Agenda Item 4

1. Report Summary

1.1 Members will recall that a Masterplan for the comprehensive development of the Pickering's Farm site, allocated as a Major development site under Policy C1, came before planning committee in September 2020. Members unanimously voted to refuse the Masterplan on a number of matters. These matters were set out in a letter to the developers, Taylor Wimpey and Homes England following the refusal. Although some changes have been made to the current Masterplan, it has not been resubmitted as a stand alone document but rather as a supporting document to accompany two outline planning applications.

1.2 The two applications are in outline with all matters reserved except for the means of access for a residential led development. This report covers both applications, Application A and Application B with separate sections relating to each where necessary.

Figure 1 Currently Observed traffic speed variation A582 NB

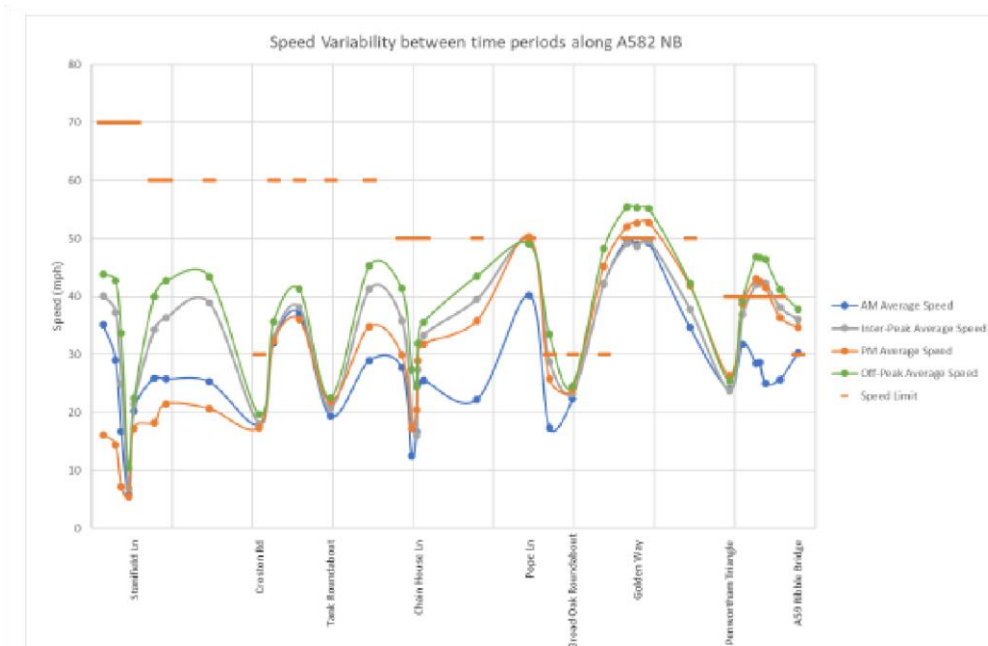
The impact of the A582 junctions on traffic speed is well illustrated in the diagram below which shows recent measured values of traffic speed. This graphic was extracted from the LCC SOBC for the A582 Widening Project Reference 14. The diagram shows the impact on Northbound traffic but the same pattern also exists for the South Bound traffic. Note the classic saw-tooth speed profile, and requirement for multiple acceleration and deceleration cycles. This sawtooth profile generates high levels of pollutants. Also note that the A582 in the vicinity of Stanifield Lane to the M6 is currently dualled and most major junctions have already been upgraded..

9 Revised estimation of delay time and economic impact for A582 (route 1).

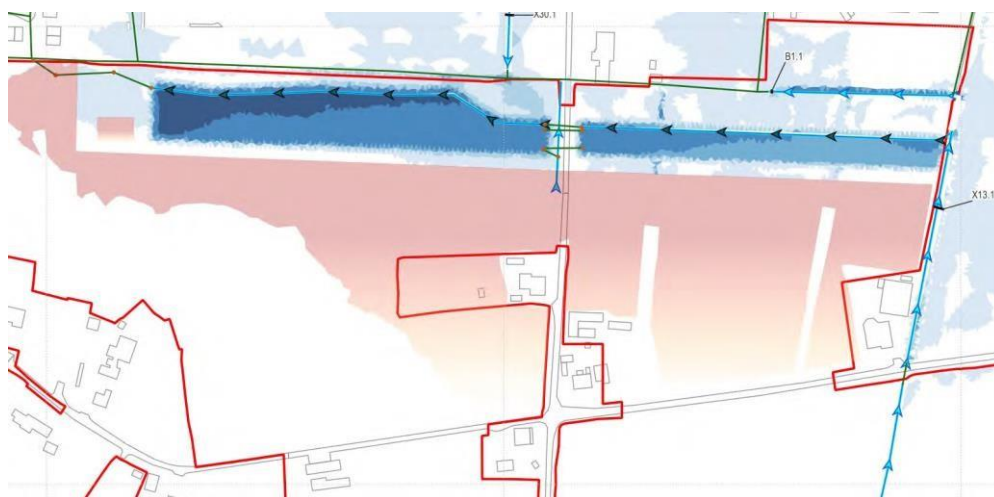
- 2.5 The proposed flood mitigation for catchment B is far more complex because of the site topography and drainage catchment area. It is concluded in the appendix 11.1 that there is insufficient gradient for gravitational flow from an attenuation basin as for catchment A. The approach proposed is to create an artificial flood basin at the north boundary of the site shown

as feature 4 on the Illustrative Master Plan. The scheme is also shown in figure 4.12 of Appendix 11.1 and on

McCloy drawing titled "Proposed Daylighting and Reprofiling" Fig No M01852-01.

Catchment B Flood Basin. The area shown in red is the raised earthworks. Note the existing properties that are totally or partially surrounded by the raised earthworks.

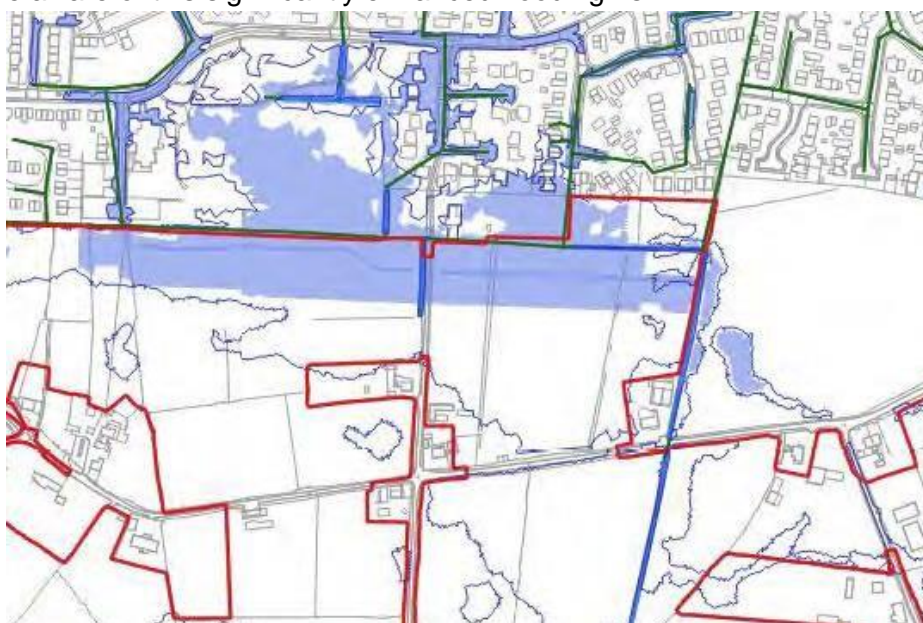
- 2.8 The proposed arrangement is shown below extracted from the McCloy drawing.

- 2.9 The design of the flood basin is such that it cannot gravity drain to Mill Brook via the Northern Culvert. What is proposed is a flow controlled pumping station. There is very little design information on the pumping station other than it will incorporate a duty and standby pump. If electrically powered it is critical that the sub-station providing the power is also flood protected. This requirement is not mentioned in the Masterplan documents. The Welsh Government Standard for the design construction and operation of surface water drainage systems 2018 states wrt pumped systems "Because of the ongoing energy and maintenance requirements of pumping water and the risks associated with failure, pumping should be avoided where possible"

Figure 3-18: Predicted on-Site Flooding (3.3% & 1% AEP)

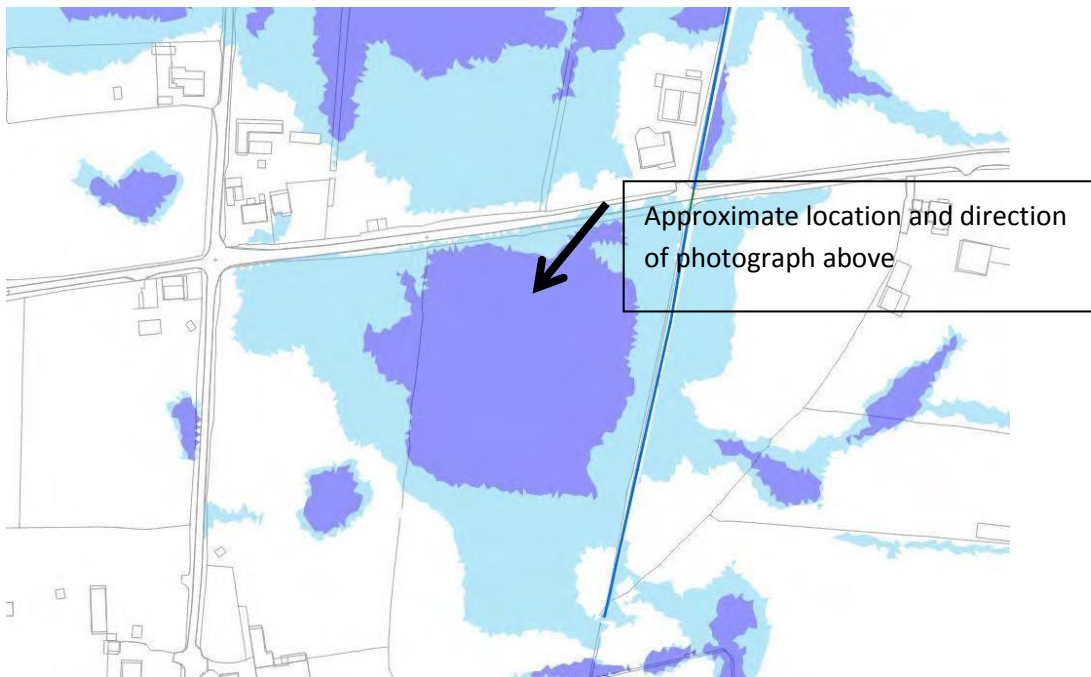
3.1 Appendix 11.1 section 3.10 deals with model validation. In this section the authors argue that pictures of "historic" flooding provided by "objectors" to the scheme in fact help validate the model. The authors imply that the two photos in question are from a one off historic event. By comparing the photos with what is predicted in the model they claim the model then accurately predicts such a "historic" event and proves the model is sound.

Light blue is the 1 in 100 year event (1% AEP) and the dark blue is the 1 in 30 year event (3.3% AEP)

Figure 3-20: Predicted on-Site Flooding (3.3% 1% AEP).

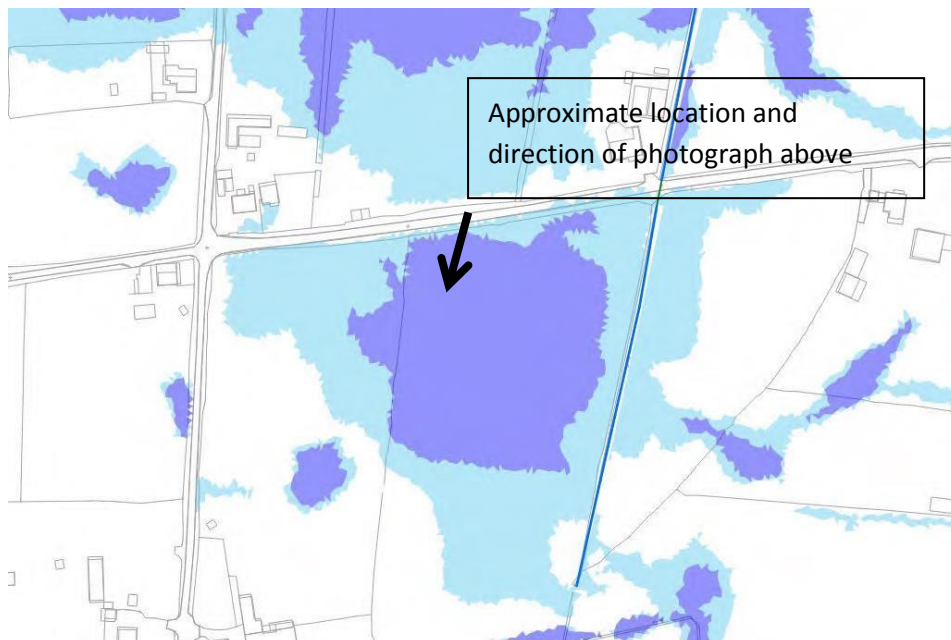
They also use the second photo below to “validate” the model.

The authors state;

The flood basin as shown on the Illustrative Master Plan (marked as feature 4)

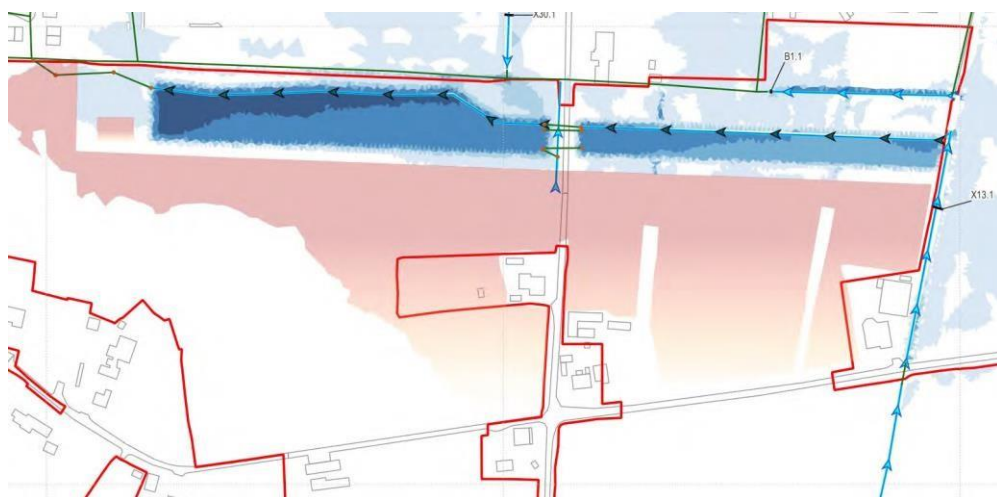
shown as feature 4 on the Illustrative Master Plan. The scheme is also shown in figure 4.12 of Appendix 11.1 and on

McCloy drawing titled “Proposed Daylighting and Reprofiling” Fig No M01852-01.

2.6 The drawing shows a flood basin with a capacity of 16,205 m³ Appendix 11.1 table 4.5. The estimated area of the flood basin is 400 x 20m. What is concerning is that water is channelled into the flood basin by employing raised earthworks to the south of the flood basin which are raised to a minimum level of 0.63 m above the predicted 100-year event water level. Ref page 40 of appendix 11.1. It is noted that no earthworks maximum height is given again demonstrating extreme design uncertainty. This statement leaves the developers with the freedom to raise earthworks significantly higher e.g. 1m+, with significant environmental detriment to the existing properties. This does not appear a credible solution given the impact the earthworks will have on existing property owners.

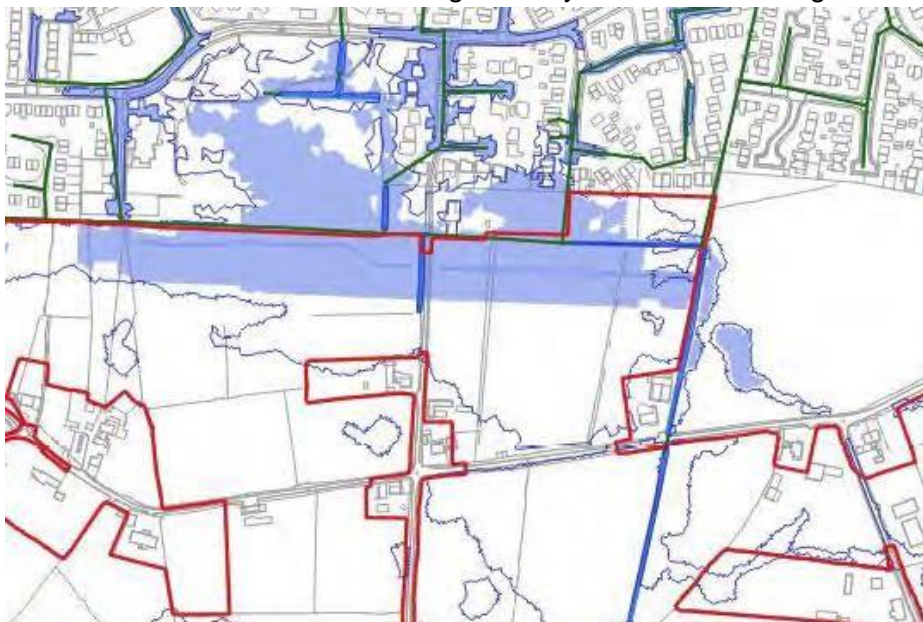
2.15 It is clear in the appendix 11.1 that the flood basin is designed to protect the site. What may not be apparent to the reader of the Masterplan documents is that the impact of the flood basin design is to considerably increase the risk of flooding to properties in Kingsfold to the north of the flood basin. The diagram below, next page, shows the impact of the proposed flood basin design on Kingsfold. It is unlikely that the residents of Kingsfold or the appropriate authorities are aware of this significantly enhanced flooding risk.

Note this figure given as Fig 4.15 in the Appendix 11.1 shows the flood basin filled and overflowing into Kingsfold in the case of a 1 in 100-year event plus a 40% global warming allowance. Note the raised earthworks to the immediate south of the flood basin “protect” the site at the expense of Kingsfold which has no protective earthworks. Note the diagram does not show the full extent of flooding in Kingsfold; and that the Penwortham Town Council Building appears to be impacted by flooding.

Figure 3-20: Predicted On-Site Flooding (3.3% 1% AEP).

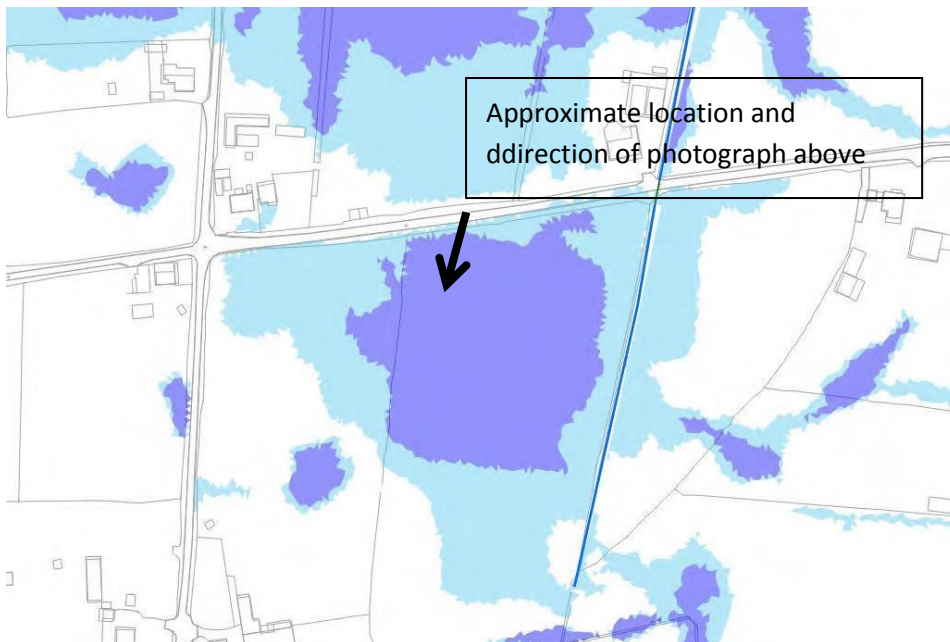
They also use the second photo below to “validate” the model.

The authors state;
